USCG COMMENT 1 (PARAGRAPH 1 & 2):

CRC RESPONSE TO COMMENT 1 (PARAGRAPH 1 & 2):

Exhibit 4-5 from the Navigation Technical Report: USACE Columbia River at Vancouver Water Level Data (1987-2006)

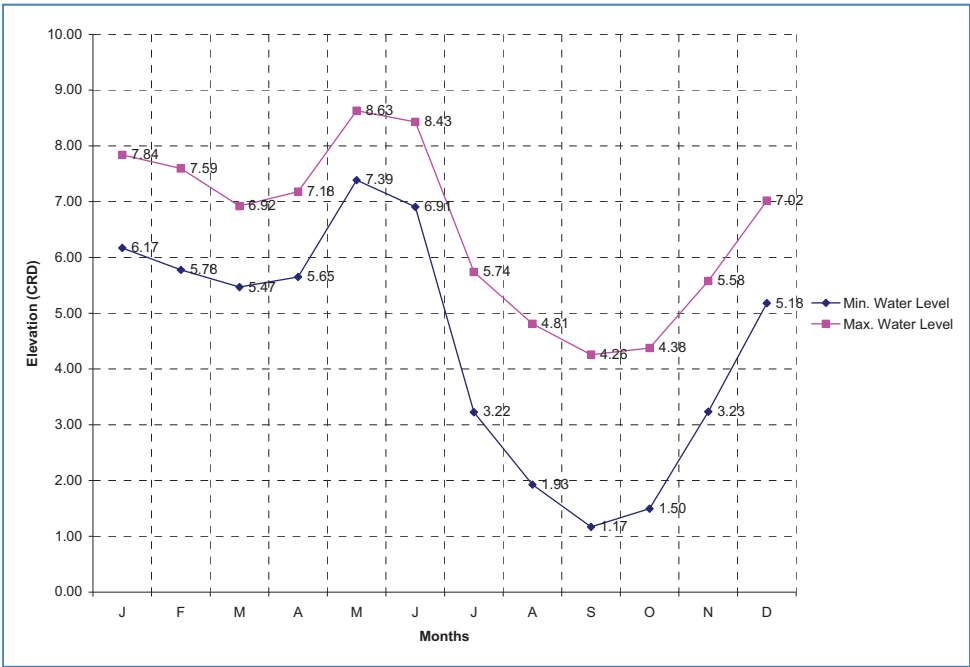
Address the vertical clearance provided by the LPA at various water stages of the Columbia River and whether those reduced clearances negatively impact the safe and efficient movement of any present or prospective public, commercial and recreational users operating on the waterway.
--

The bridge height was determined using data from the U.S. Army Corps of Engineers’ (USACE) Columbia River recording station at Vancouver that records the water level several times each day. Both the minimum and maximum recorded daily water levels are available.

This data was depicted in the Navigation Technical Report in two different ways: 1) the graph (Exhibit 4-5 from the Navigation Technical Report) below depicts the average monthly minimum and maximum water levels over this time period, and 2) the available vertical clearance for each of the tugs and tows, high mast sailboats, and marine contractors.
